SUBJECT: SUSQUEHANNA STEAM ELECTRIC STATION, UNITS 1 AND 2 - ISSUANCE OF AMENDMENTS RE: REVISIONS TO TECHNICAL SPECIFICATION 3.4.10, "RCS PRESSURE AND TEMPERATURE (P/T) LIMITS" (TAC NOS. MF4597 AND MF4598)

Amendment No. 263
Renewed License No. NPF-14

Amendment No. 244
Renewed License No. NPF-22

SAFETY EVALUATION BY THE OFFICE OF NUCLEAR REACTOR REGULATION
RELATED TO AMENDMENT NO. 263 TO RENEWED FACILITY OPERATING
LICENSE NO. NPF-14 AND AMENDMENT NO. 244
TO RENEWED FACILITY OPERATING LICENSE NO. NPF-22
SUSQUEHANNA NUCLEAR, LLC
ALLEGHENY ELECTRIC COOPERATIVE, INC.
SUSQUEHANNA STEAM ELECTRIC STATION, UNITS 1 AND 2
DOCKET NOS. 50-387 AND 50-388

FIGURE 3.4.10-1
 System Hydrotest Limit with Fuel in Vessel for 40 EFY
 (Curve A)

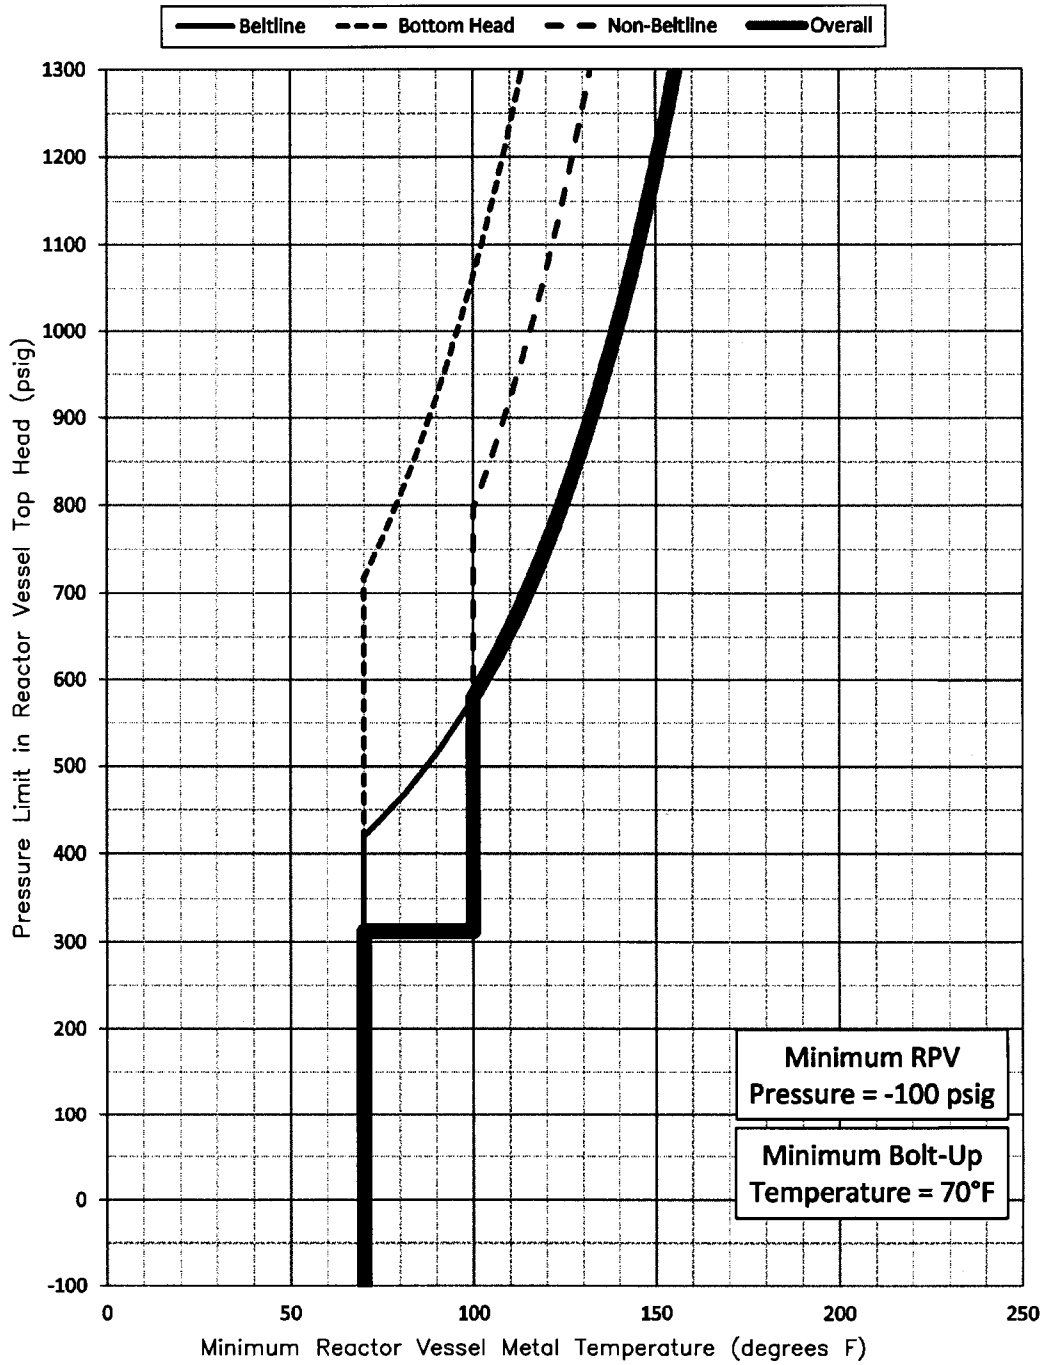
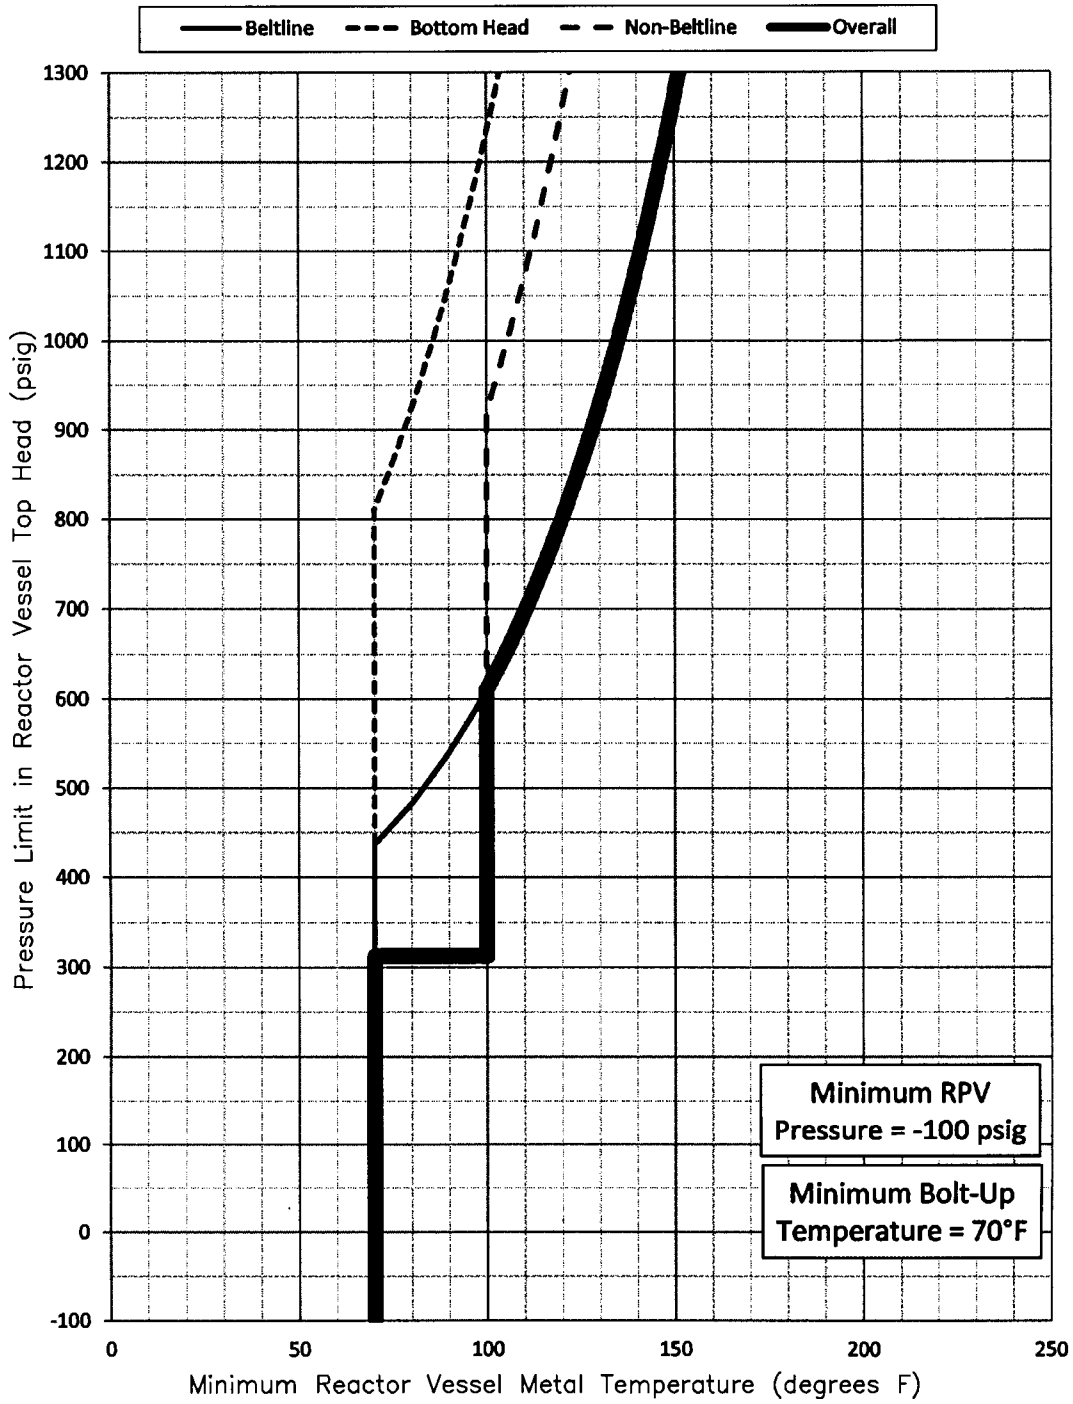
In Reference 1, the licensee proposes the following changes to the TS Figures 3.4.10-1, 3.4.10-2, and 3.4.10-3, which show the P/T Limits curves for in-service leakage and hydrostatic

- The pressure axes are revised to extend below 0 psig to bound RCS conditions to support vacuum-assist fill of the RCS loops.

The pressure axes are extended one additional scaled unit of measure (100 psig each) below 0 psig to bound RCS conditions to support vacuum-assist fill of the RCS loops. Section 4.0 of the LAR states, in part: "The absolute maximum vacuum is assumed to be no greater than 15 psig. This assumes the possibility of drawing a near perfect vacuum on the vessel, coupled with a 0.5 psig containment pressure."

In Reference 2, the licensee further updated the P/T Limits curves based on an updated analysis that addresses considerations included in RIS 2014-11. The new curves account for updated surveillance material and fluence data for the RV beltline materials and would replace the current 35.7 and 30.2 EFPY P/T Limits curves for SSES-1 and 2, respectively, with new curves that are valid for 40 EFPY.

In its response to RAI-1 submitted in Reference 2, the licensee provided revised P/T Limits curves to replace the P/T Limits curves submitted as TS Figures 3.4.10-1, 3.4.10-2, and

Reference 1 proposed changes to the TS Figures 3.4.10-1, 3.4.10-2, and 3.4.10-3 for the P/T Limits curves for SSE-1 and 2, extending the pressure below 0 psig. The revisions clarify that pressure limits are considered to be met for pressures that are below 0 psig (i.e., up to and including full vacuum conditions). Certain operating practices, such as vacuum fill operations for the RCS, are common practice in both boiling water reactors and pressurized-water reactors and can result in system pressures below 0 psig. Although the RV is not specifically evaluated for negative pressures, the magnitude of the negative pressure is limited to one atmosphere and thus is not expected to result in significant stresses. A perfect vacuum on the vessel would be -14.7 psig. Because the P/T Limits curve figures were revised to extend to -100 psig, the NRC staff asked RAI-2 to the licensee to provide a justification for extending the curves beyond -15 psig. In Reference 2, the licensee provided analyses to demonstrate that the RV cylinder, bottom head and top head locations, have adequate structural margin for values of negative pressure in excess of -100 psig, which significantly exceeds the vacuum pulled on the RV. The licensee noted that during vacuum fill conditions, the maximum drywell pressure of approximately 2 psig should be considered as well for a total of -16.7 psig. While this is the practical limit, the NRC staff concluded that the calculations demonstrated that the RV cylinder, bottom head and top head locations, have structural margin for values in excess of -100 psig. In its response to RAI-2, the licensee stated, in part:

Based on its review of the licensee's submittals, the NRC staff approves the extension of the P/T Limits curves by an additional unit of scale on the pressure axis. The NRC staff determined that although there is a practical restriction to the absolute maximum vacuum of approximately -16.7 psig, adequate structural margin for values of negative pressure in excess of -100 psig exists. Therefore, the NRC staff finds the revisions to SSES-1 and 2 TSs addressing pressures below 0 psig by one unit of scale to be acceptable. This resolves RAI-2.

concludes that the proposed 40 EFPY P/T Limits curves, submitted by Reference 2, are acceptable for incorporation into SSES-1 and 2 TSs. In addition, the NRC staff concludes that the proposed changes to SSES-1 and 2, TS 3.4.10, "RCS Pressure and Temperature (P/T) Limits," to address vacuum fill operations of the RCS, meet the requirements of 10 CFR Part 50, Appendix G. Therefore, the changes to the TSs are acceptable.
